AGENDA
Design Review Committee
October 13, 2021 – REGULAR MEETING
5:00 PM

Town of Jackson Design Guidelines Checklist

Item Number: P21-082

Address: 105 E. Broadway Avenue

CACHE STREET ELEVATION

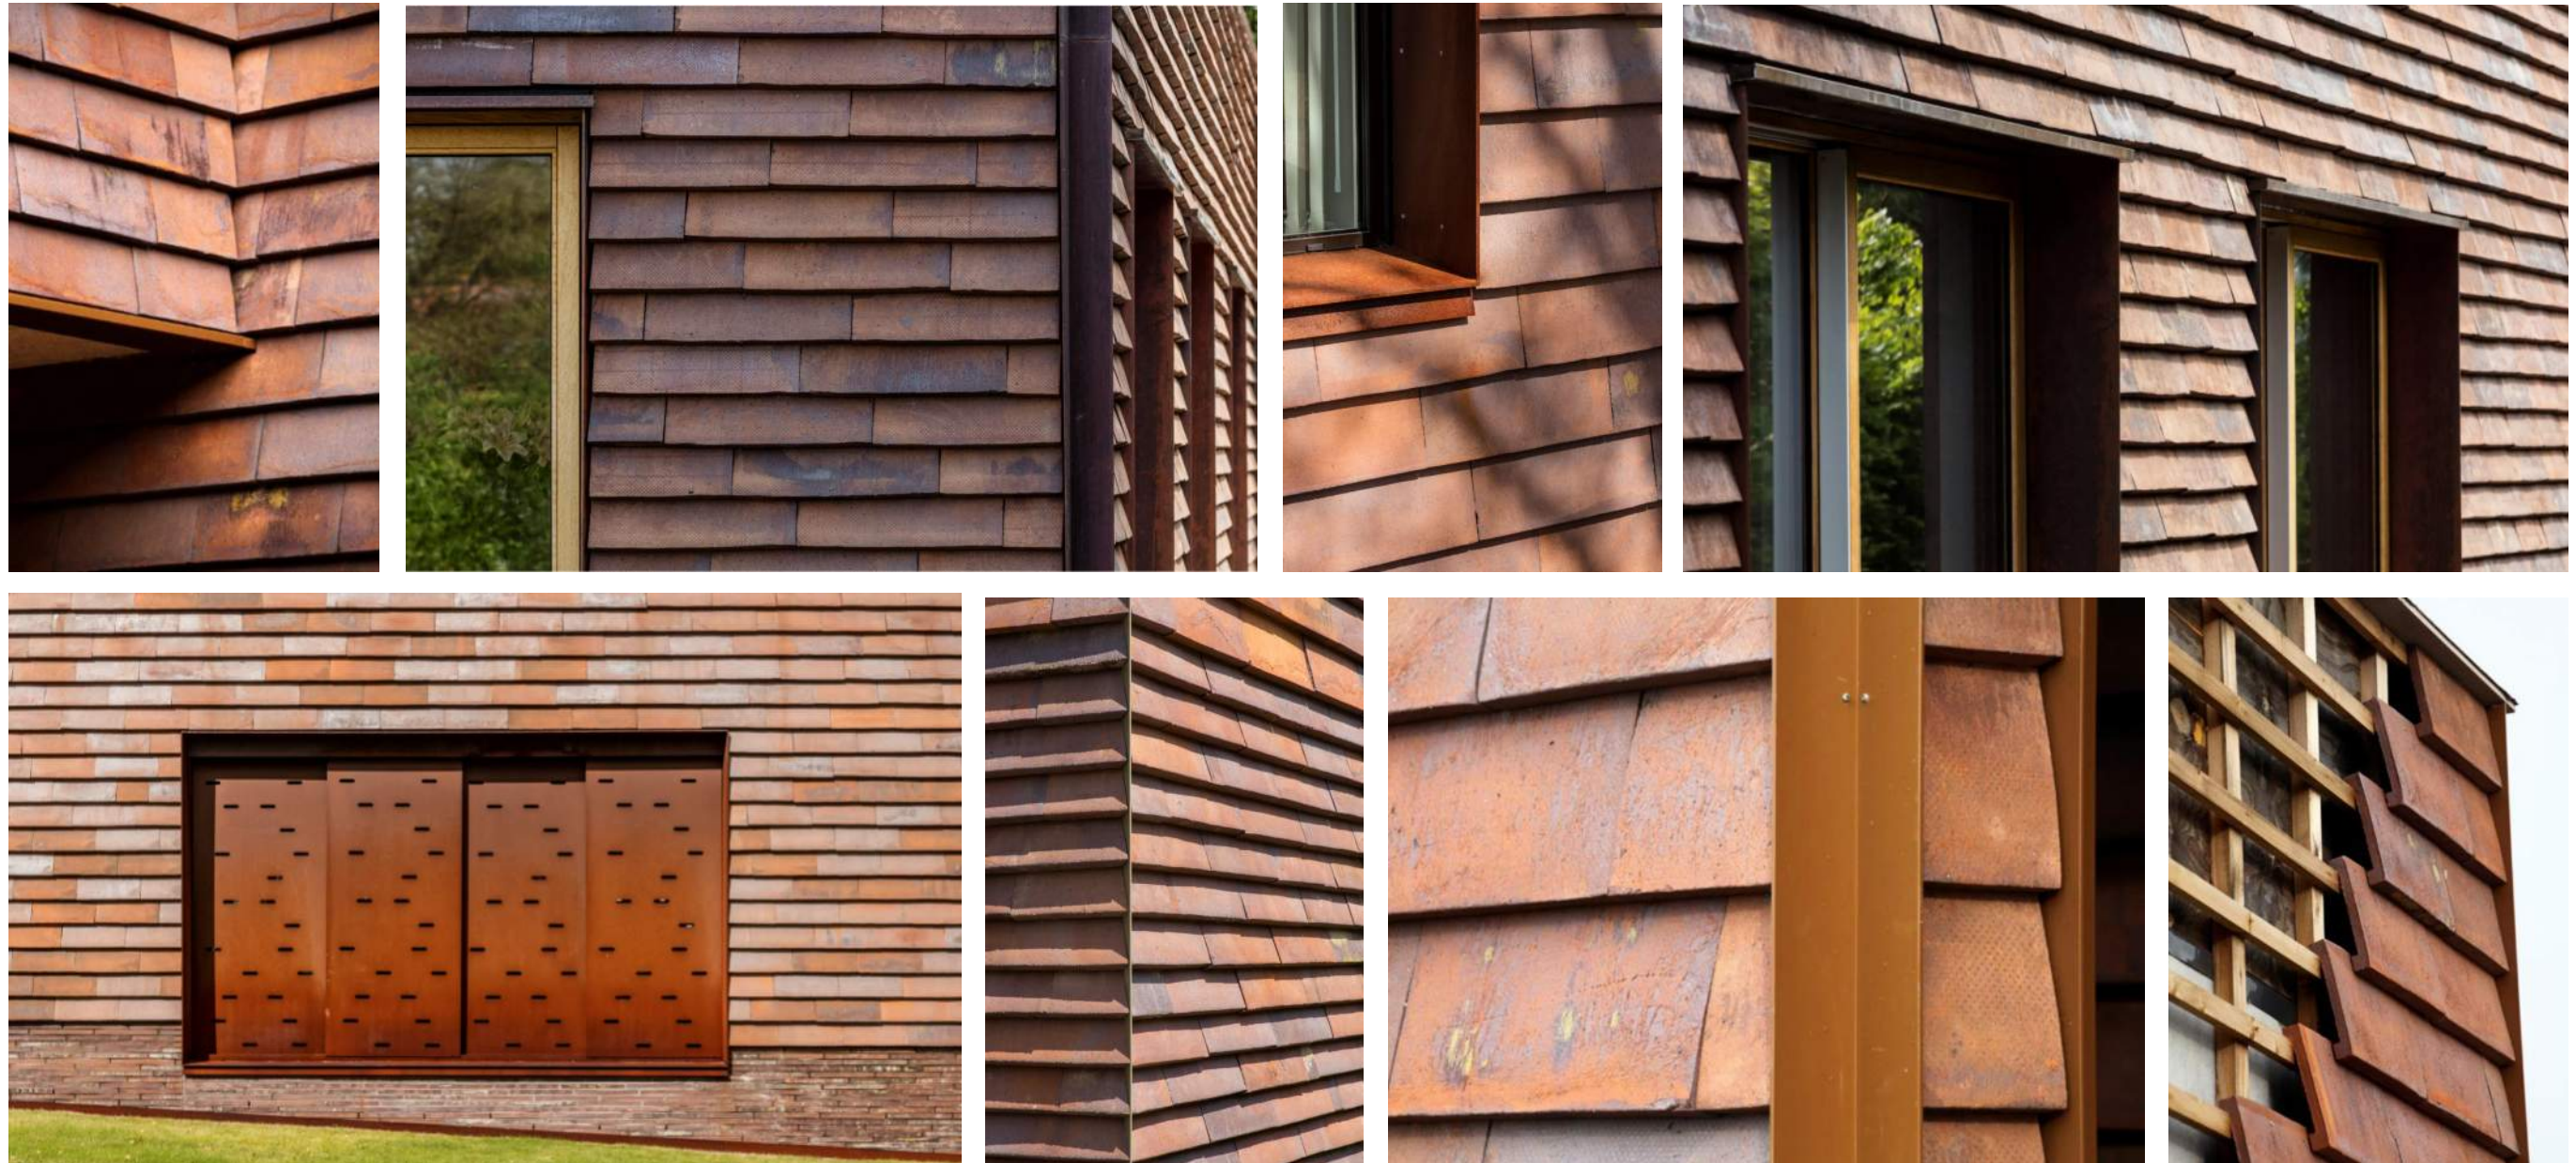
- Ground Level bays - The ground-level bays, or modules, were too large and monotonous/repetitive. The applicant should seek to provide some variation to these bays so that the pedestrian experience is not the same 3'x3' windows for 500' (350' on Pearl + 150' on Cache).

- Variation – Both vertical and horizontal variation is lacking in the design. The applicant needs to address how the ground level differs from the floor above, while also providing horizontal change in the design to help lessen the length and scale of the building.

- ② ACCENTUATED CORNICES WITH ADDITIONAL ARCHITECTURAL DETAILING AND RELIEF
- ③ VARIED PLANE OF FACADE, WITH ALTERNATING PARAPET HEIGHTS, TO CREATE RHYTHM OF PROJECTING AND RECESSED BAYS AND MORE ARTICULATED BUILDING MASSING

- ⑤ REDUCED AMOUNT OF GLAZING THROUGHOUT ELEVATIONS
- ⑥ ADDITIONAL VARIATION IN WINDOW TYPES AND SIZES PROVIDED THROUGHOUT. PUNCHED WINDOWS ADDED IN CERTAIN AREAS TO ENHANCE THE RESIDENTIAL CHARACTER OF THE FACADE

| ① UPPER LEVEL SETBACKS INTRODUCED ALONG ENTIRE LENGTH OF STREET-FACING ELEVATIONS TO LESSEN THE PERCEIVED BUILDING HEIGHT AND ENHANCE THE RELATIONSHIP WITH THE NEIGHBORING BUILDINGS | ③ VARIED PLANE OF FACADE, WITH ALTERNATING PARAPET HEIGHTS, TO CREATE RHYTHM OF PROJECTING AND RECESSED BAYS AND MORE ARTICULATED BUILDING MASSING | ⑤ REDUCED AMOUNT OF GLAZING THROUGHOUT ELEVATIONS | ⑦ UNIQUE RESIDENTIAL ENTRY DOORS UTILIZED TO DIFFERENTIATE FROM RETAIL DOORS |
| ② ACCENTUATED CORNICES WITH ADDITIONAL ARCHITECTURAL DETAILING AND RELIEF | ④ STONE INTRODUCED AS A PRIMARY FACADE MATERIAL TO COMPLIMENT CLAY FACADE TILES (IN LIEU OF BRICK) AND FURTHER REDUCE THE PERCEIVED SCALE OF THE BUILDING MASSING | ⑥ ADDITIONAL VARIATION IN WINDOW TYPES AND SIZES PROVIDED THROUGHOUT. PUNCHED WINDOWS ADDED IN CERTAIN AREAS TO ENHANCE THE RESIDENTIAL CHARACTER OF THE FACADE | ⑧ ADDITIONAL DARK WOOD SIDING PROVIDED IN LIEU OF METAL PANEL AT TOP LEVEL RESIDENTIAL UNITS |
